Update report Stakeholder feedback template:

AEMO Review of technical requirements for connection

Stakeholder: Bo Yin

Schedule 5.2 Conditions for Connection of Generators

Figure. 1 two terminal system with known system impedance

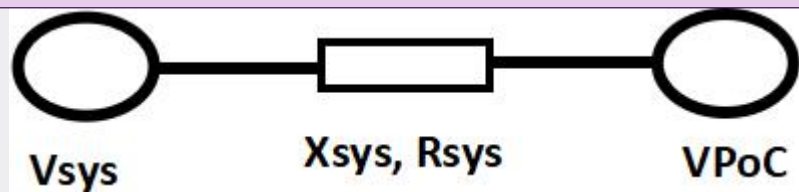
Based on the given values of SCR, X/R, VPoC, PPoC, and QPoC, the voltage value ($Vsys$) can be solely determined. In order to further analyze and address the points mentioned, let's delve into the specifics of the operating points for voltage regulation.

By restricting $Vsys$ to the range of 0.9 to 1.1 pu, we can determine the corresponding $Qbase$, which represents the maximum allowable reactive power to maintain $Vsys$ within the specified limit. This information is presented in the table below, highlighted in

By examining the table, it can be observed that for an SCR of 10, the upstream voltage reaches its lowest limit of 0.9 pu when Qmax is at 0.395 pu. However, for an SCR of 3, the same voltage limit is reached with Qmax at 0.04 pu. From this analysis, it can be concluded that only a small amount of reactive power is required for voltage regulation in a weakened grid scenario.

Taking this perspective into account, it is highly valuable for AEMO to undertake an investigation aimed at determining the precise amount of reactive power being utilized by power plants. Such an investigation would not only shed light on the actual utilization of reactive power in real-world scenarios but also offer valuable insights for optimizing system designs and making informed investments.

Figure.2 voltage slope control characteristic

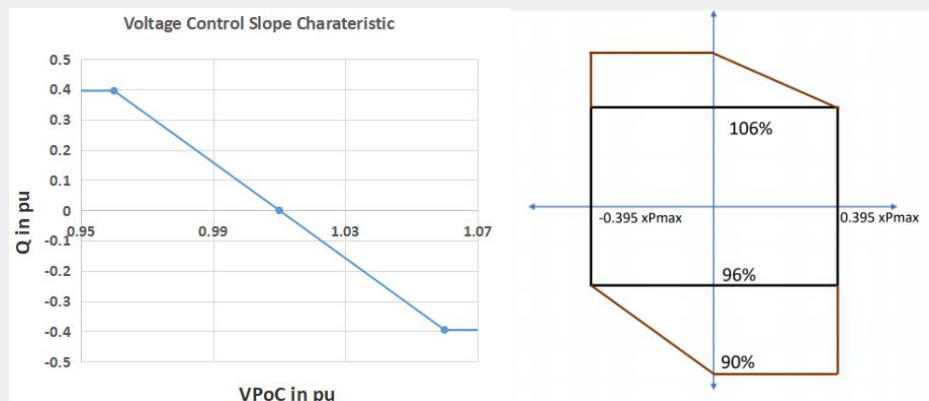
Let's assume voltage slope control is applied at the PoC using the equation $VPoC = Vref - (Droop * QPoC / Qbase)$, as shown in Figure 2. Here, $Vref$ is set as 1.01pu and Droop is set as 0.05, with the intention of operating within a voltage range of 0.96pu to 1.06pu.

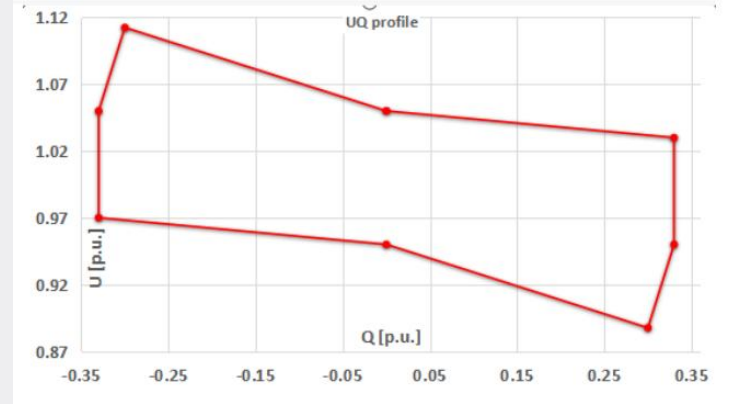
Thirdly, when it comes to specifying the voltage range for the full reactive power requirement, it is important to consider the system's needs and make efficient investments. For effective voltage regulation, a high inductive reactive power (Q) is needed at high voltage levels, particularly when there is low active power production. Conversely, a high capacitive reactive power (Q) is needed at low voltage levels, especially when there is high active power production. However, it is worth noting that providing a large amount of reactive power at low voltage levels requires a higher RMS current rating for the inverter, which translates to increased costs. Achieving a balance between the system's requirements and cost-effectiveness can be achieved through a voltage profile that accommodates both aspects.

In conclusion, understanding the actual reactive power requirements in real-world scenarios, in combination with considering the system's needs and optimizing cost-efficiency, will contribute to specifying an appropriate reactive power capability requirement at the point of connection.

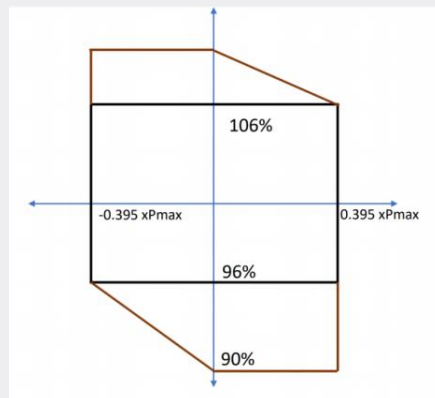
Finally, it is essential for NSPs to coordinate and specify the mid-point voltage and voltage range for both 5.2.5.1 and 5.2.5.13 in a coordinate way if the reactive power capability is defined with a mid-point voltage as shown in below . This coordination ensures accurate and consistent in reactive power capability and voltage control in the plant.
